# Elizabeth Drive East Upgrade

## Submissions Report

October 2024

Figure 5-2: Recorded threatened species – Sheet 2 of 6

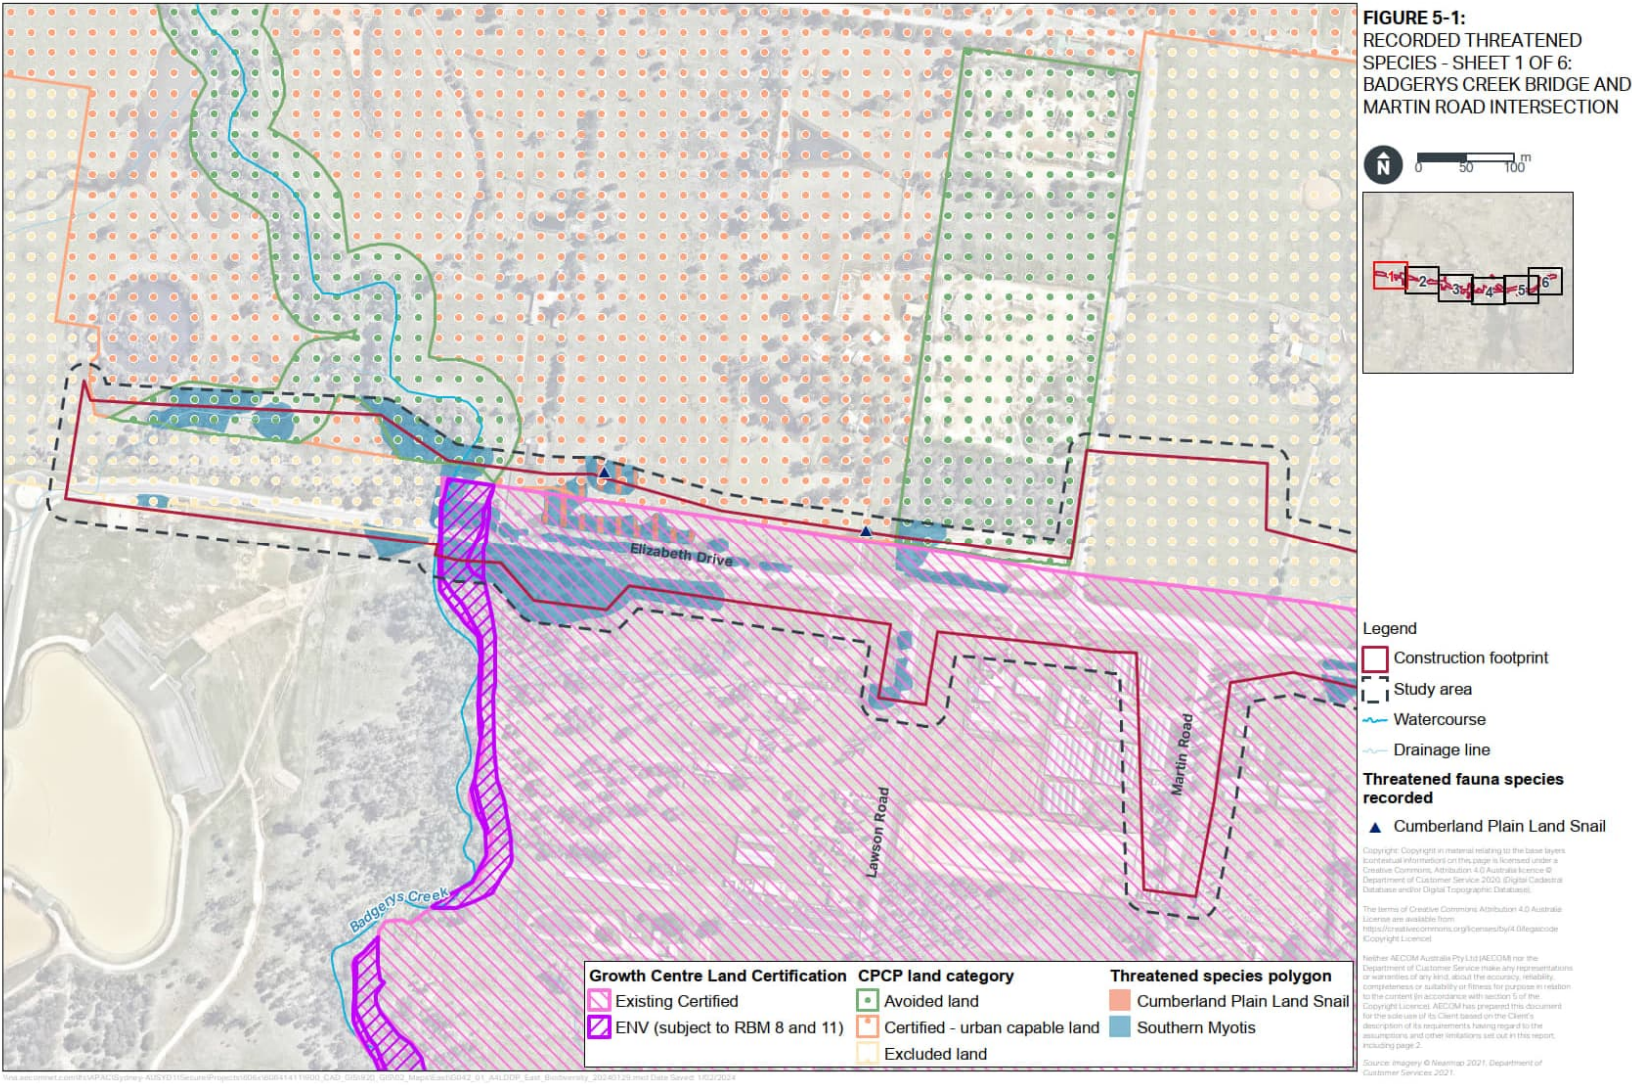
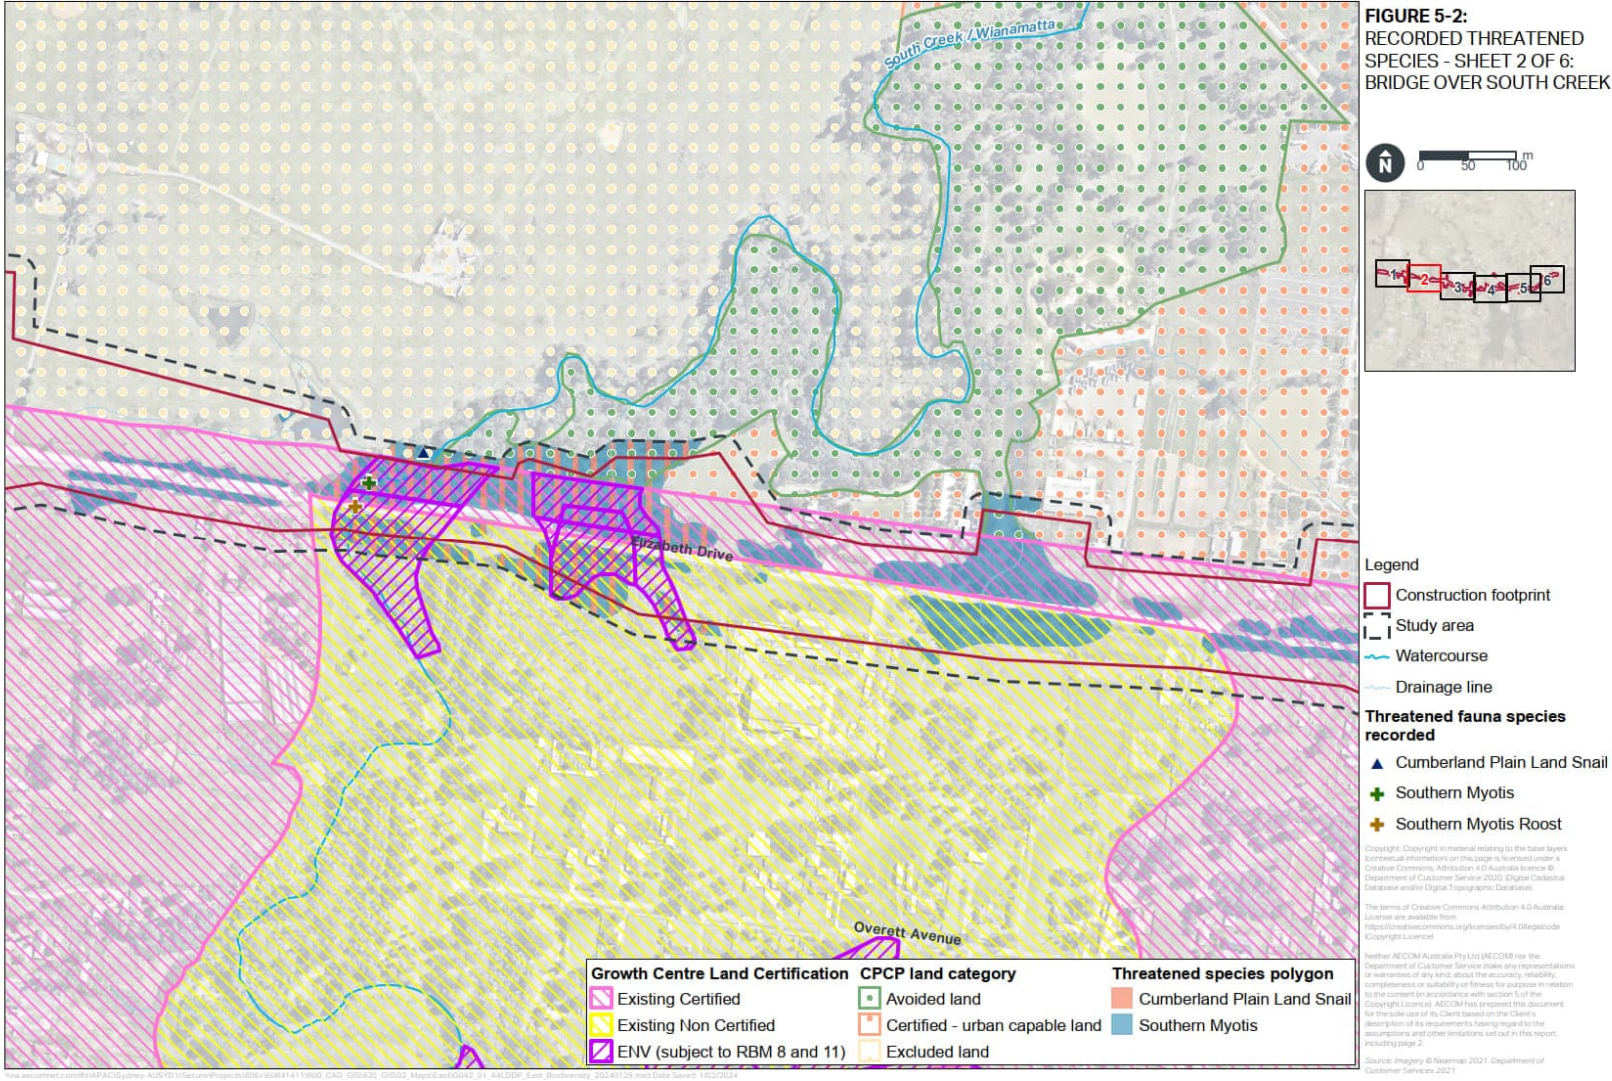
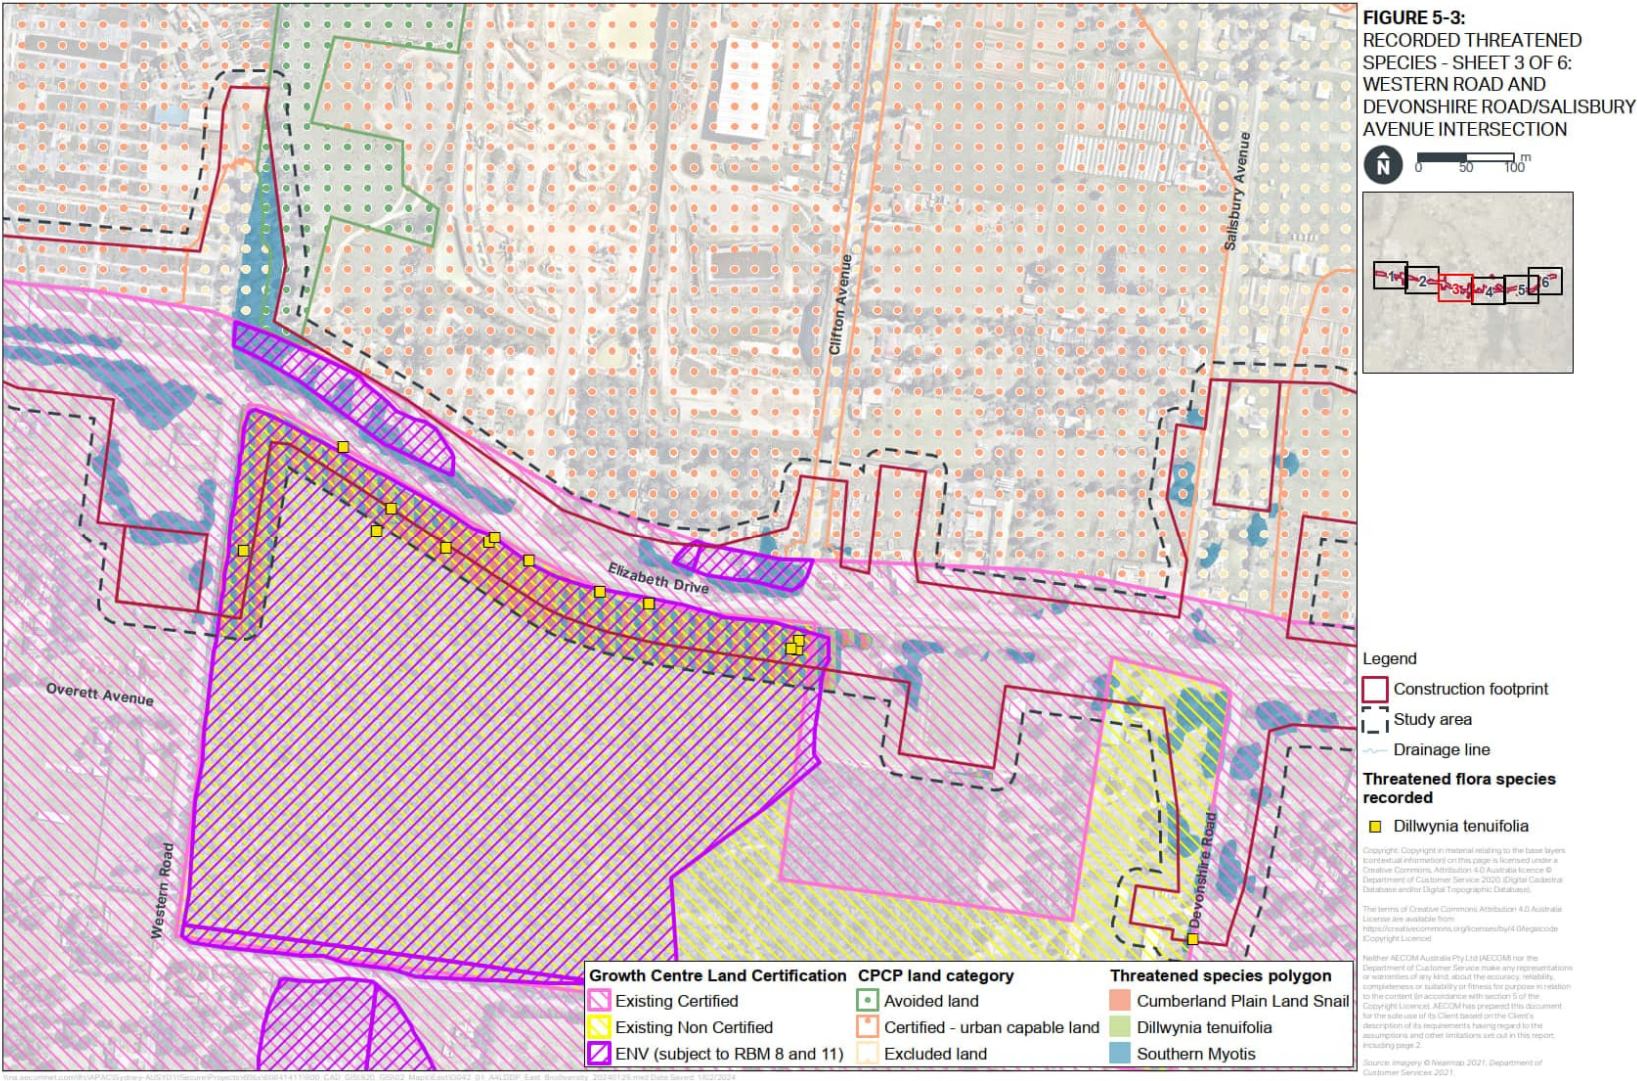
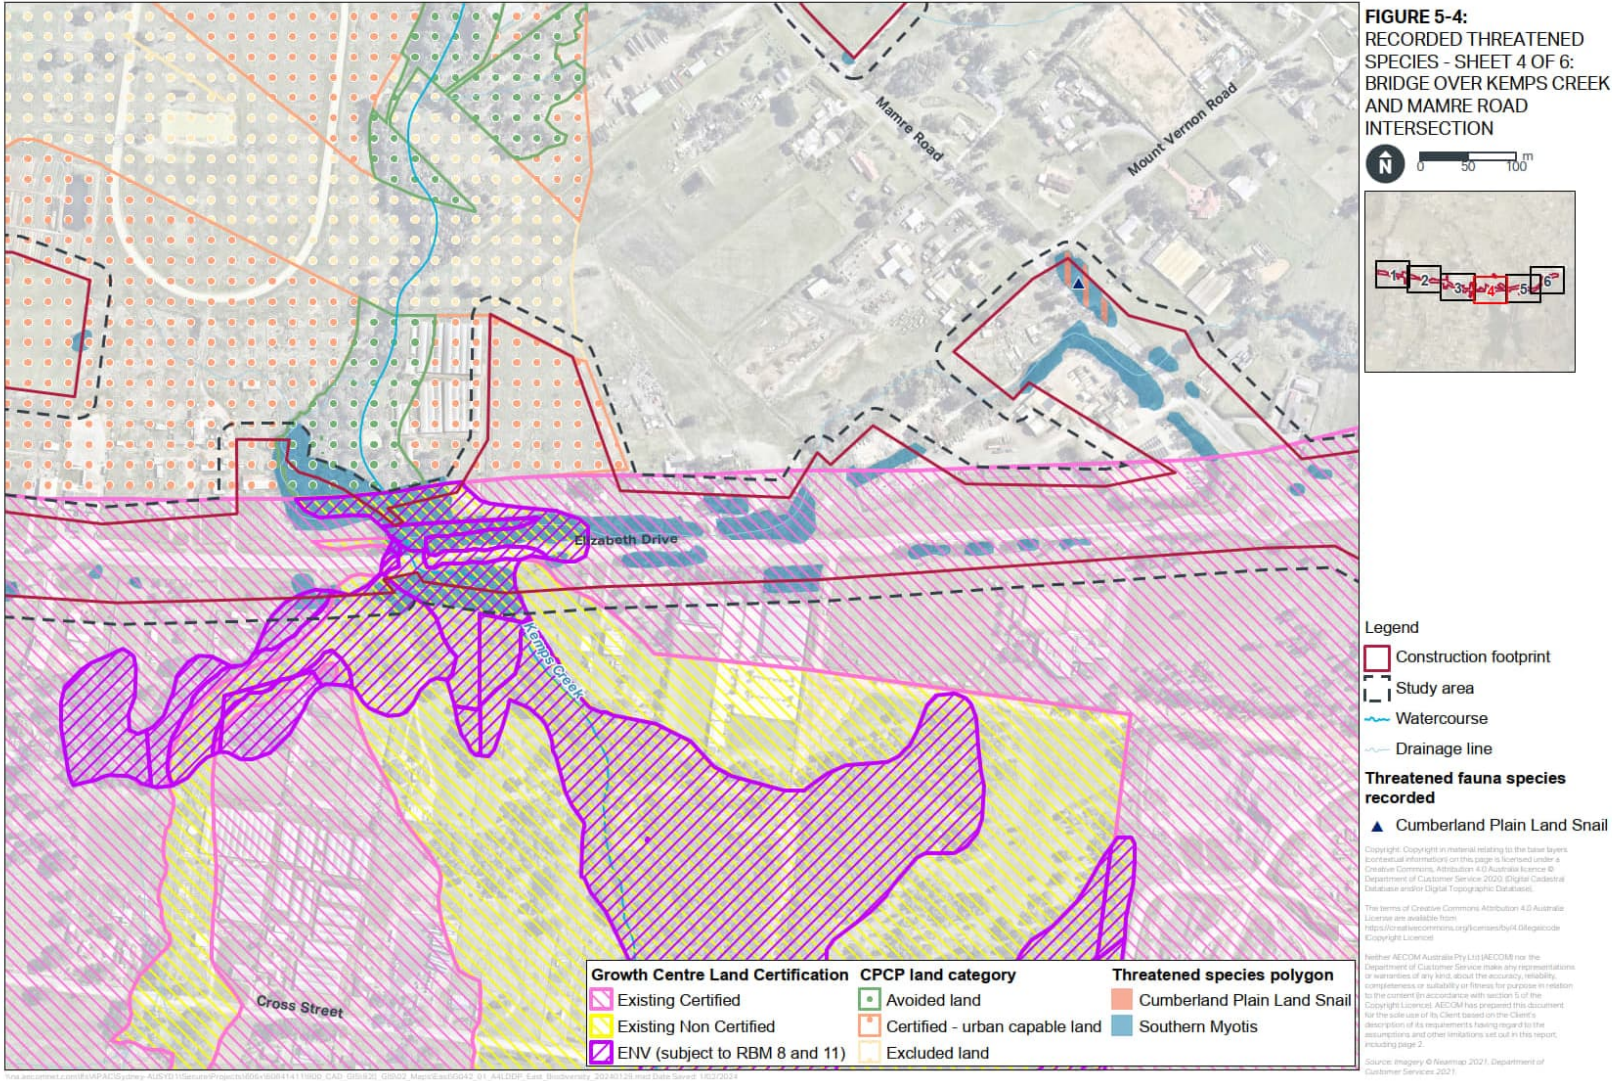
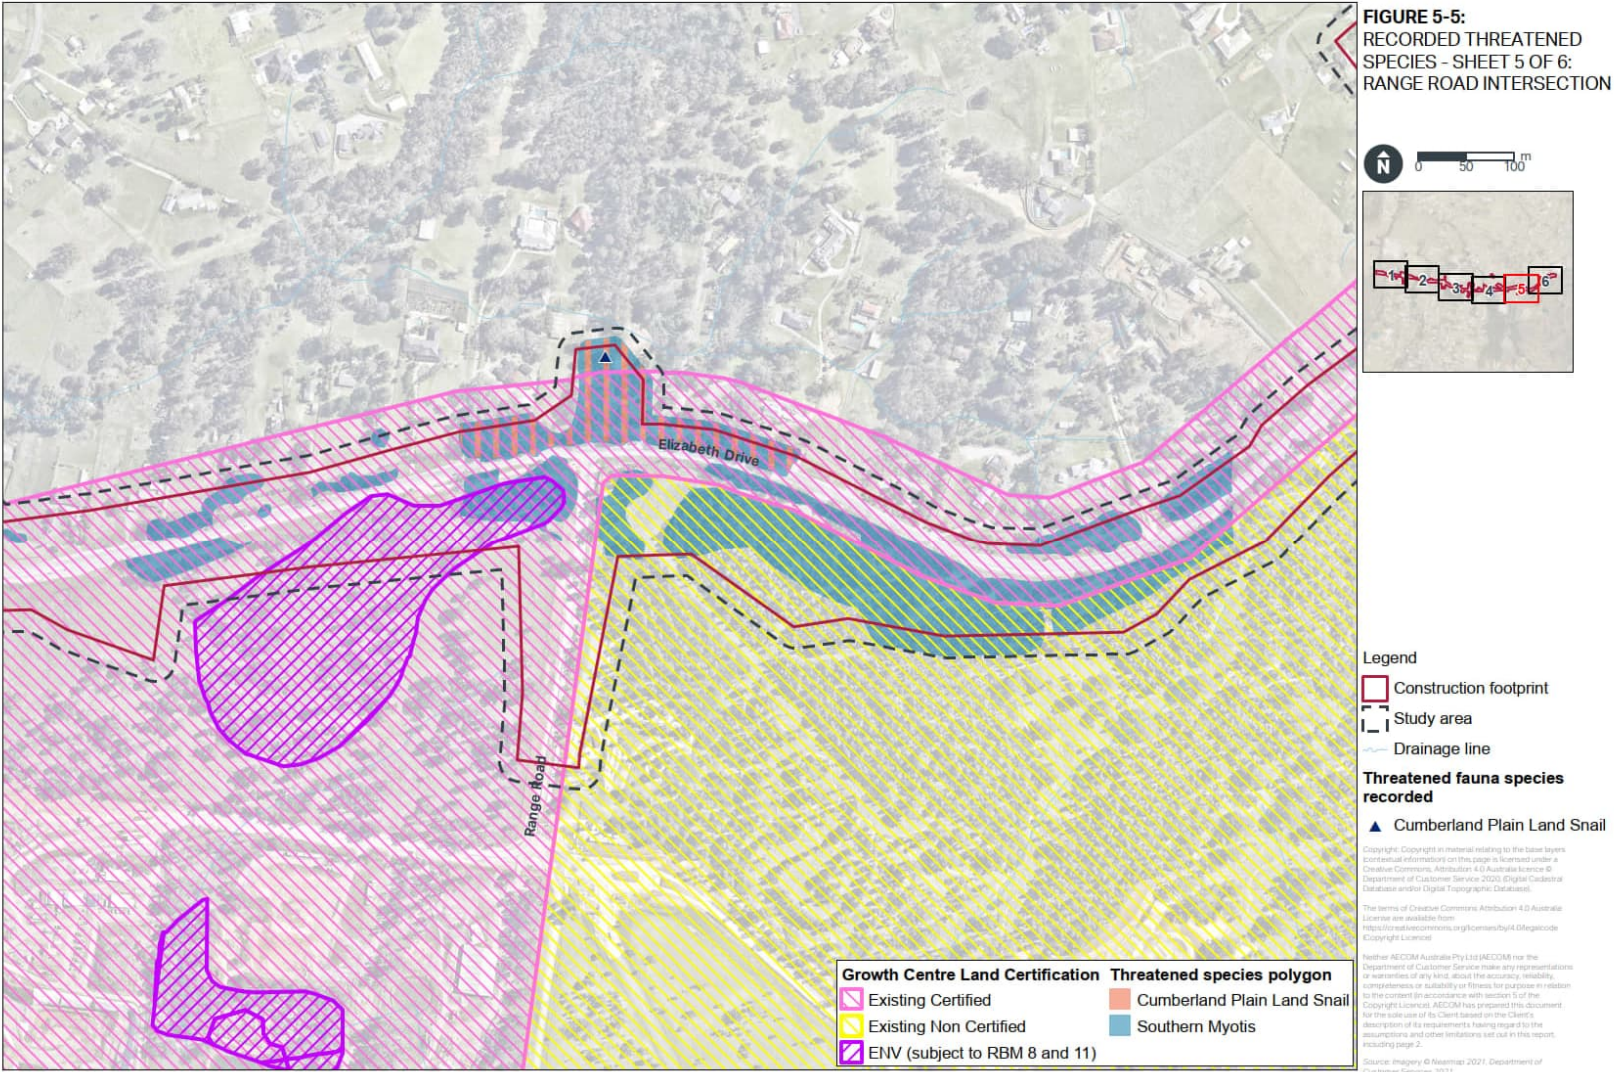
Council noted that threatened species maps were not included. Figure 3-4 only includes a single map which shows the species polygon for *Acacia bynoeana* and maps for all other threatened species have not been included. Council advised that this missing information adds to the difficulty of understanding the potential distribution and impacts to threatened species.

The revised BAR (Appendix B) includes an updated version of Figure 3-4 which presents the location of recorded threatened species during targeted surveys carried out in October and November 2023. This includes the following species:

A summary of the threatened species considered to have a ‘moderate’ or ‘higher’ likelihood of occurring within the study area following targeted surveys carried out in October and November 2023 is provided in Table 5-2. These species were recorded during the surveys. The recorded threatened species are also shown in Figure 5-1 to Figure 5-6.
